DEVELOPMENT DETERMINATION PANEL MEETING

WEDNESDAY 9 OCTOBER 2024

ITEM 3.1 DA2024/0142 - 111 ADDISON ROAD MANLY - DEMOLITION AND CONSTRUCTION OF 2 SEMI-DETACHED DWELLINGS WITH POOLS AND 2 LOT SUBDIVISION

DEVELOPMENT APPLICATION ASSESSMENT REPORT

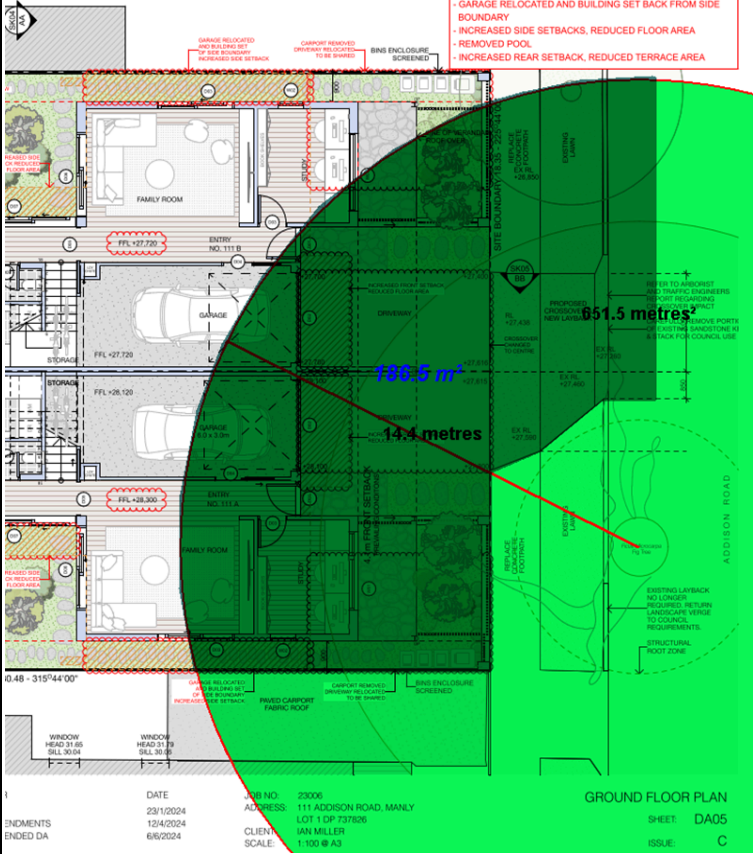
Internal Referral Body	Comments
	 <i>Fig. 4 Fig tree lateral root within the subject site circled yellow.</i> The Geotechnical report prepared by Crozier Geotechnical Consultants indicates the presence of shallow soils with sandstone outcropping within the site. (Fig. 5).

Internal Referral Body	Comments
	<i>Photograph-4: View of the sandstone outcrops. View looking south..</i> <i>Fig 5 Natural sandstone outcrop within the site circled yellow.</i> Concern is raised regarding the cumulative effect on the tree of all works proposed given the shallow soils and location of roots close to the surface. In addition to the excavation required for the driveway layback, crossover and localised road re-sheeting, additional impacts are proposed. Excavation for the proposed OSD tanks and pipes, construction of retaining walls, excavation for slabs, services and regrading of existing surfaces levels are indicated within the TPZ of the tree. Assessment of the combined impacts on the tree indicates that 186.5m² or 28.6% of the theoretical TPZ is likely to be affected (Fig 6). If the area of the theoretical TPZ located in the roadway is excluded (as explained above), the percentage of the area of impact on lateral roots is much higher.

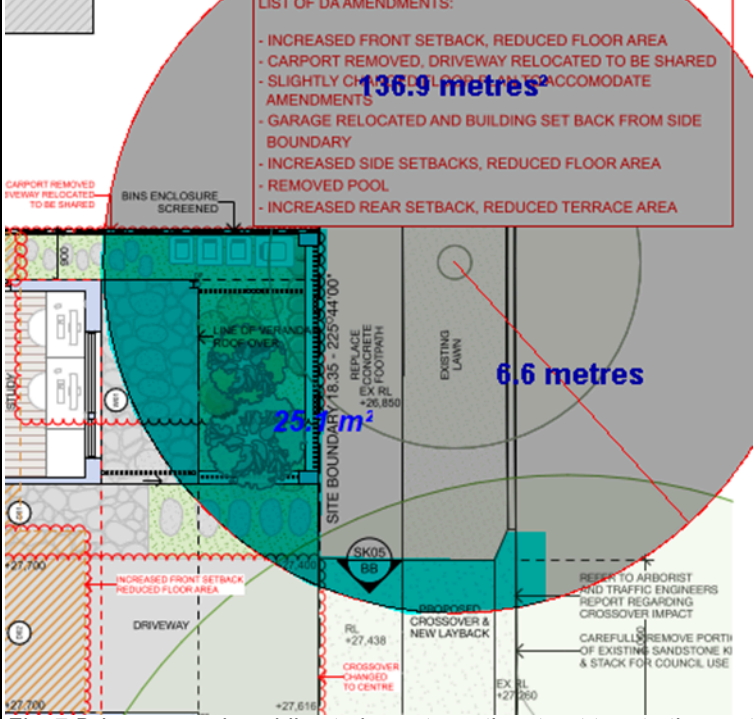
Internal Referral Body	Comments
	 LIST OF DA AMENDMENTS: - INCREASED FRONT SETBACK, REDUCED FLOOR AREA - CARPORT REMOVED, DRIVEWAY RELOCATED TO BE SHARED - SLIGHTLY CHANGED FLOOR PLAN TO ACCOMMODATE AMENDMENTS - GARAGE RELOCATED AND BUILDING SET BACK FROM SIDE BOUNDARY - INCREASED SIDE SETBACKS, REDUCED FLOOR AREA - REMOVED POOL - INCREASED REAR SETBACK, REDUCED TERRACE AREA 136.9 metres 6.6 metres 25.4m² Fig. 7 Driveway works adding to impacts on the street tree to the east (shaded). The tree displays a significant number of surface roots in the road reserve, which further indicates shallow soils (Fig. 8). The deletion of the driveway component would also be of benefit to that tree.  Fig. 8 Significant tree roots either side of the street tree to the east

Internal Referral Body	Comments
	The proposed driveway and parking arrangement indicated on the amended plans is therefore not able to be supported in this instance. <u>Amended Comments (4 April 2024):</u> The amended Arborist's Report is noted. The Report still references Tree 2 as being retained, though presumably it is actually referring to T1. However, no details have been sighted regarding the proposed driveway adjacent to T1. It is evident that excavation is required to be boundary as shown on the Cut and Fill Plan, but no indication of the crossover levels and width have been provided. The Arborist's Report also appears not to have considered the extent of excavation as indicated in the Cut and Fill Plan. Combined with impacts of the crossover, the extent of excavation would appear to exceed the 11% incursion into the TPZ of T1 that is listed in the Report. There is insufficient detail to demonstrate the construction of the crossover can be achieved without impacting The TPZ and the Structural Root Zone of the tree, nor that an acceptable crossover width can be provided. Proposed works should be designed above existing ground levels to minimise impacts on T1. Details of the crossover and driveway, including cross sections, are required to ensure that impacts on tree roots are avoided. There is a real concern that vehicular access on the western side of the site cannot be achieved and may need to be deleted from the application.

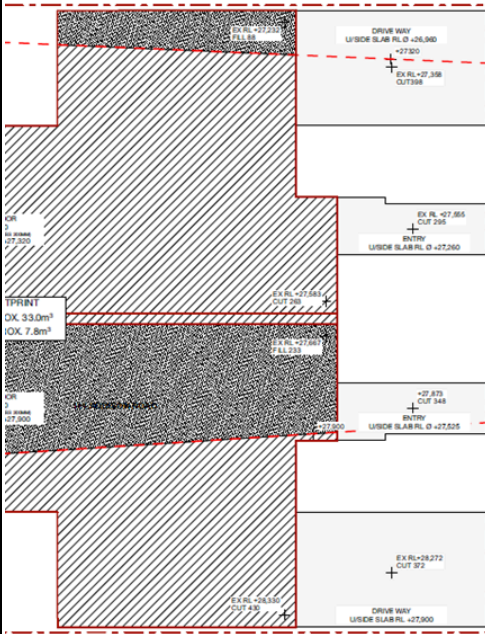
Internal Referral Body	Comments
	 DATE: 29 FEBRUARY 2024 JOB NO: 23006 ADDRESS: 111 ADDISON ROAD, MANLY EXCAVATION & FILL DIAGRAM <u>Original Comment (29 February 2024):</u> The application seeks consent for: Demolition and construction of 2 semi-detached dwellings with pools and 2 lot subdivision. The plans prepared by Watershed, Arborist's Report and Landscape Plans, both prepared by Ezigrow, are noted. The Plans and Report are contradictory in relation to the removal of the street trees. However, the cut and fill plan indicates significant earthworks in the vicinity of the trees, necessitating removal. The proposed works will clearly require removal of the two street trees forward of the property. The street trees in Addison Road are listed items of Environmental Heritage under Manly LEP. Advice provided at pre-lodgement indicated that removal of the street trees would not be supported. The proposal is not supported with regard to landscape issues due to proposed removal of the trees.
